Access Compliance Report

Public Rights-of-Way

(Curb Ramps)

Intersection ID: 27772	Main Street: BRIARWICK_LN	Cross Street: NORTH_COMMUNITY_HOUSE_RD	Location: NW
ADA ID: 78B6F2DF1B5D	Ramp Type: Perp	Initial Pass/Fail: Fail	Overall Compliance: No Severity Score: 33.75

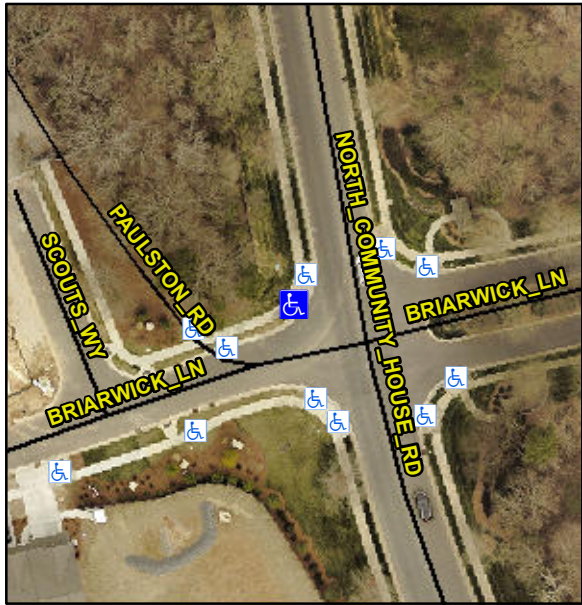
Codes/Mitigation Info/Possible Solution			Field Measurements/Component Compliance					
	Possible Solutions:		Compliance	Description	Data	Compliance	Description	Data
	Remove & Replace Entire Ramp.		N/A	Ramp Length (in)	108.0	No	Ramp Slope (%)	10.1
			No	Ramp Width (in)	37.5	No	Ramp XSlope (%)	6.1
			N/A	Flare Type LT	N/A	N/A	Flare Type RT	N/A
			N/A	Flare Slope LT (%)	N/A	N/A	Flare Slope RT (%)	N/A
			N/A	Flare Traversable LT?	N/A	N/A	Flare Traversable RT?	N/A
			N/A	Landing Length (in)	N/A	N/A	DWS Provided?	N/A
			N/A	Landing Width (in)	N/A	N/A	DWS Contrast?	N/A
			N/A	Landing Slope (%)	N/A	N/A	DWS Length (in)	N/A
			N/A	Landing X Slope (%)	N/A	N/A	DWS Full Width?	N/A
Surveyor Notes:		N/A	N/A	Landing Curb? (Y/N)	N/A	N/A	DWS Offset (in)	N/A
PROW/ADA:		Not Found, R304.5.1, R304.2.2, R304.5.3	N/A	Shared Landing?	N/A			
			N/A	Gutter Ponding?	N/A	N/A	Gutter Slope (%)	N/A
			N/A	Gutter Lip Ht (in)	N/A	N/A	Gutter X Slope (%)	N/A

N/A	Painted X Walk1?	No	N/A	Painted X Walk2?	N/A
				X Walk 1 Direction	To SW		X Walk 2 Direction	N/A
			N/A	X Walk 1 Width (in)	N/A	N/A	X Walk 2 Width (in)	N/A
				X Walk 1 Slope (%)	2.0		X Walk 2 Slope (%)	N/A
				X Walk 1 X Slope (%)	5.8		X Walk 2 X Slope (%)	N/A
			N/A	Ramp inside XWalk1?	N/A	N/A	Ramp inside XWalk2?	N/A
				Road Slope (%)	N/A	N/A	Clear Space?	N/A
				Road X Slope (%)	N/A	N/A	Clear Space to XWalk (in)	N/A
			N/A	Any Obstructions?	N/A	N/A	Storm Grate/Utility Hazard?	N/A
				Obstruction Type			Storm Grate/Utility Type	
					N/A			N/A
						Yes	Surface Condition? (G/P)	Good
Total Cost:		\$ 1850.00
